Access Compliance Report

Public Rights-of-Way

Intersection ID: 16090	Main Street: SARAH_DR	Cross Street: STEGALL_ST	Location: W
ADA ID: 28EBF6954351	Ramp Type: PerpDiag	Initial Pass/Fail: Fail	Overall Compliance: No
Codes/Mitigation Info/Possible Solution		Field Measurements/Component Compliance

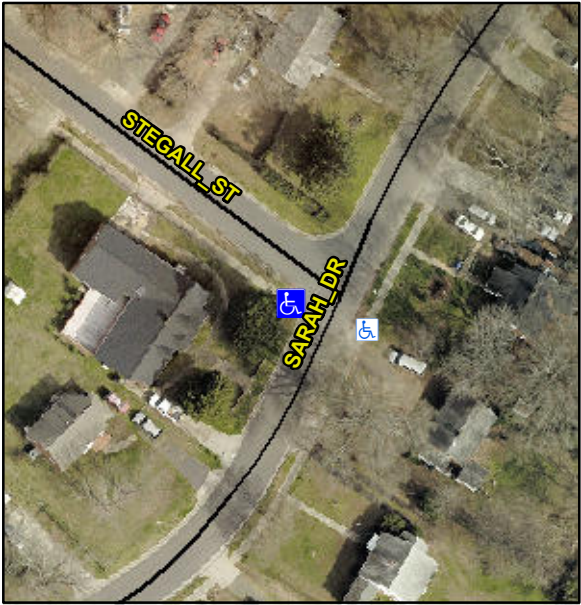
Possible Solutions:			
	Remove & Replace Curb Ramp With Two New Directional Ramps or Equivalent.			
<p>Surveyor Notes:</p> <p>N/A</p>	<p>PROW/ADA:</p> <p>Not Found, R304.5.1, R304.2.2</p>	Compliance	Description	Data
		N/A	Ramp Length (in)	47.0
<p>Street 1 Name</p> <p>SARAH DR</p>	<p>Stop Condition-Street 2</p> <p>None</p>	No	Ramp Width (in)	47.0
		N/A	Flare Type LT	N/A
<p>Street 2 Name</p> <p>STEGALL ST</p>	<p>Stop Condition-Street 1</p> <p>StopSign</p>	N/A	Flare Slope LT (%)	N/A
		N/A	Flare Traversable LT?	N/A
<p>Total Cost:</p> <p>\$ 3200.00</p>		N/A	Landing Length (in)	N/A
		N/A	Landing Width (in)	N/A
		N/A	Landing Slope (%)	N/A
		N/A	Landing X Slope (%)	N/A
		N/A	Landing Curb? (Y/N)	N/A
		N/A	Shared Landing?	N/A
		N/A	Gutter Ponding?	N/A
		N/A	Gutter Lip Ht (in)	N/A
		N/A	Painted X Walk1?	No
			X Walk 1 Direction	To SE
		N/A	X Walk 1 Width (in)	N/A
			X Walk 1 Slope (%)	6.1
			X Walk 1 X Slope (%)	2.0
		N/A	Ramp inside XWalk1?	N/A

Road Slope (%)	5.1
			Road X Slope (%)	4.7
		N/A	Any Obstructions?	N/A
			Obstruction Type	
		N/A		N/A
		Yes	Surface Condition? (G/P)	Good
